Workgroup Consultation Response Proforma

CMP434: Implementing Connections Reform

This response is provided on behalf of RUK Members (referred to as “members” throughout the document). The response has been produced following several workshops and offline review cycles during the consultation window and the preceding weeks. Given the breadth of membership, several views presented are not unanimously agreed with most notable differences in opinion outlined.

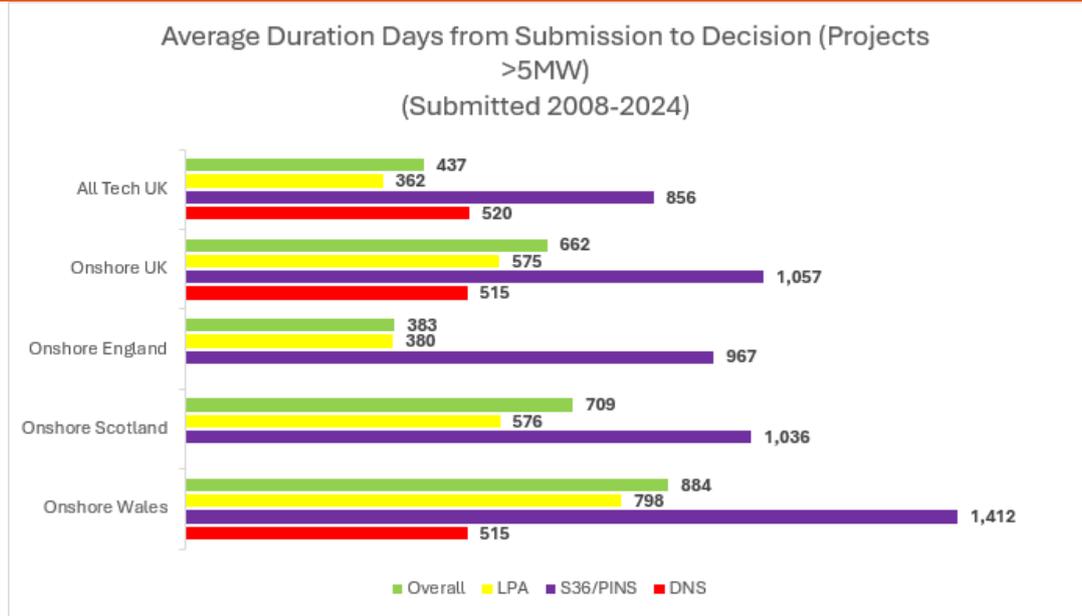
- **Offshore Wind** – Timelines for previous leasing rounds have been reviewed. While timelines would depend on the criteria for offshore LoAs, a comparison was prepared by a member to highlight how projects could reach their Longstop Date based on past processes.

Noted this is based on the announcement date from The Crown Estate (TCE) and Crown Estate Scotland (CES). It does not consider any Gate window cut off dates.

While CMP435 seeks to address the Celtic Sea case, the above illustrates that 3 years may not always be sufficient without work arounds or exceptions. Given there are multiple interacting elements to this proposal, with aspects yet to be fully defined, some members request the approach for offshore projects is more clearly defined. Similar comment noted under Element 5.
